**SITE PLAN REVIEW COMMITTEE
MEETING AGENDA**

Item 1. 11th & Vermont/1031 N. Vermont Street (SP #447) 7:00pm–8:30 pm
(RPC#s 14-018-001; -002; -005; -006; -018; -070)
Planning Commission and County Board meetings to be determined.
Matthew Pfeiffer (CPHD Staff)

ITEM 1
11th & Vermont (SP #447)
(RPC#s 14-018-001; -002; -005; -006; -018; -070)

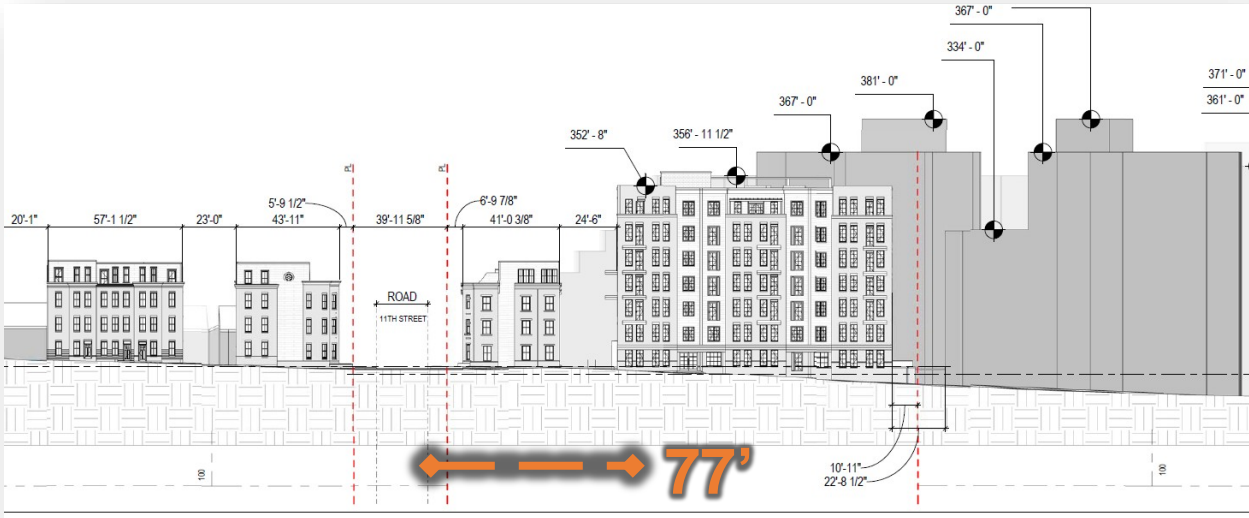
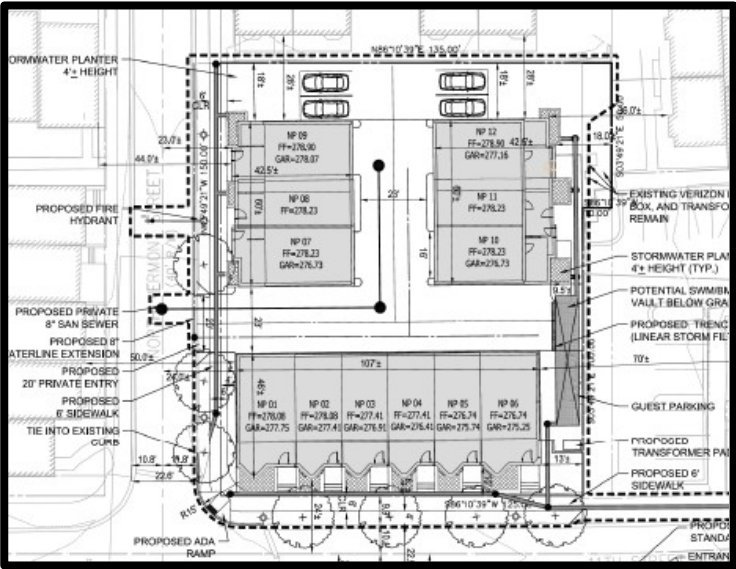
GLUP Study Recommendations and Guidance: As mentioned above, the Special GLUP Study recommendations for the site included guidance that the height of the structures for the first 80 feet of block depth on the South Block be limited to 3-4 stories. The applicant proposes four-story townhouse-style units that encompass the majority of this area, however the 7-story multifamily building is placed 77 feet from the back of curb along 11th Street N. While this is very close to the 80-foot standard, this should be examined in the context of the transitions on surrounding blocks to ensure an appropriate transition.

In addition to the multifamily building siting with respect to block depth, building sculpting was a tool discussed during the process to achieve both a deliberate height taper to 11th Street N. The applicant has not provided sculpting on the proposed building.

12/11/2017 UPDATE: The prior reading of this measurement failed to account for a four-foot landscape planter between the sidewalk and the face of building for the townhouses fronting 11th Street N. When this planter is taken into account, the true dimension for the placement of the multifamily building is **81 feet** from the face of curb. This placement meets the GLUP Study standard of 3-4 stories for the first 80-feet from the face of curb.

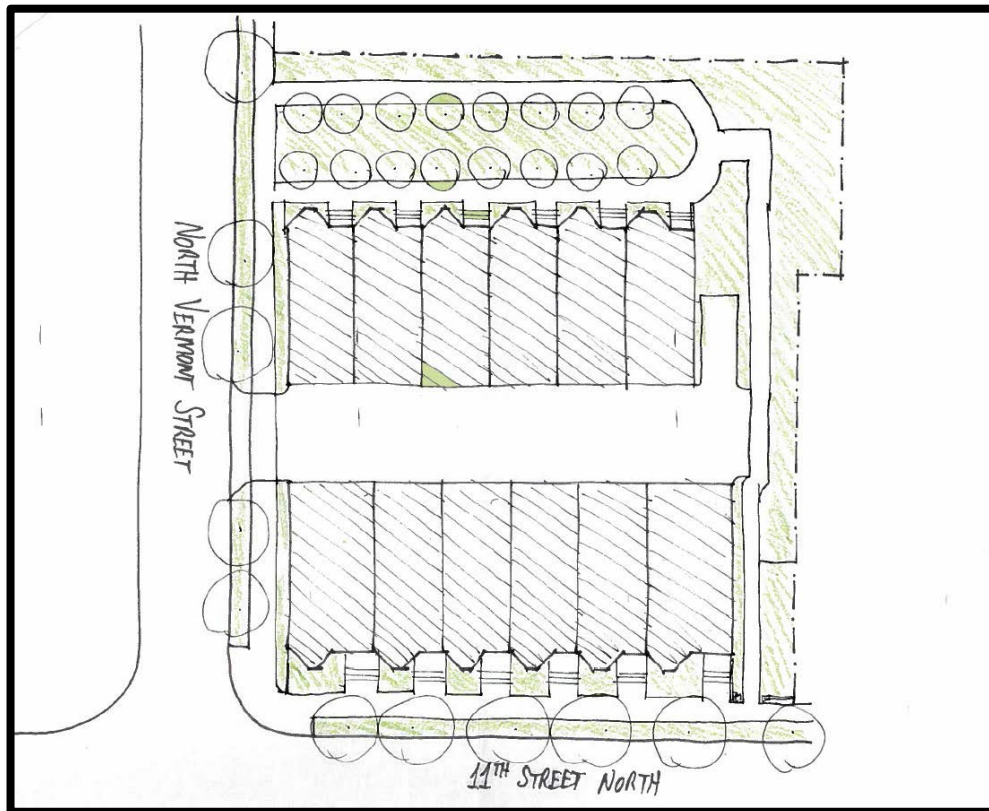
North Block Site Layout and Open Space: One item discussed during the GLUP Study process was whether and where to include open space within the project site. Ultimately this question was left up to the site plan review process to decide. Staff believes that open space provided on the North Block would be a useful element in order to provide relief from the height and density proposed, and to achieve neighborhood desires for light and air in the subject project.

Staff has also identified several issues with the proposed site layout for the townhouses in the North Block. While the sticks of townhouses along 11th Street N. and N. Vermont Street adequately frame the public realm, there is a stick of three townhouses in the interior of the site that do not contain fronts or backs and are in practical terms isolated from a public street frontage. In addition, a large proportion of the site is taken up with internal drives and surface parking for visitor spaces. Finally, the eastern portion of the site does not address the abutting development; staff is recommending that green space and pedestrian access be provided in this area. The applicant's proposal furthers many of the undesirable traits of townhouse developments approved in the vicinity during the 1980's.

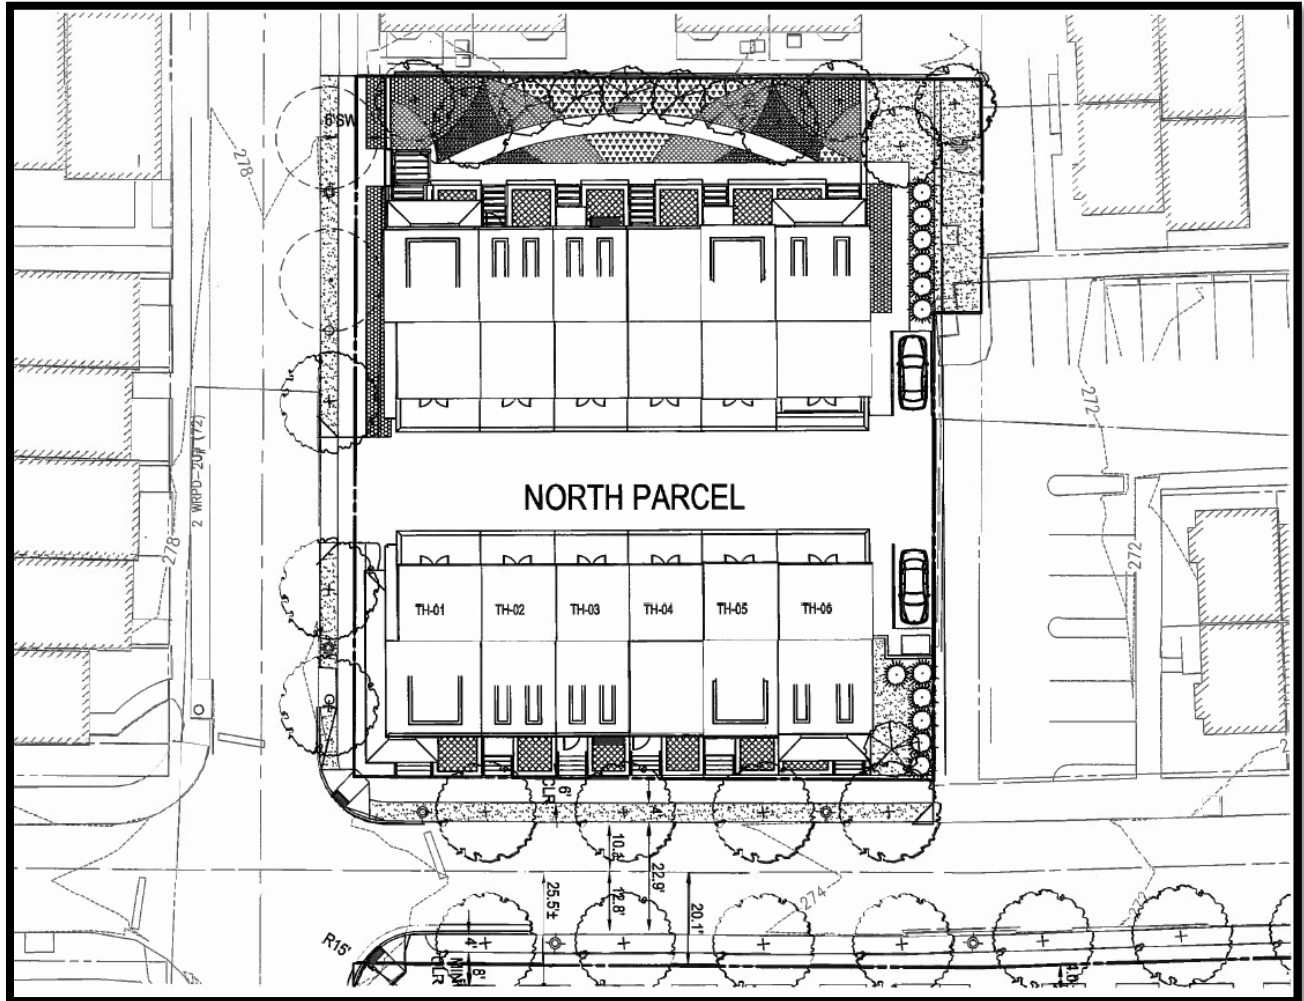
Staff has developed a sketch of what an alternative site layout that for the North Block, which incorporates a small private open space, could look like:

UPDATE 12/11/2017: Since the October 19, 2017 meeting, the applicant has worked with staff on the design of the North Block to eliminate the stick of three townhouses in the interior of the site that did not front on a public street. The applicant was also able to introduce an approximately 40-foot wide private open space along the rear property line that will act as a mews for the stick of townhouses fronting on it. Staff supports the applicant's new layout because it reduces impervious surface, orients the units toward a shared space connected to the public realm, and introduces open space into the project.
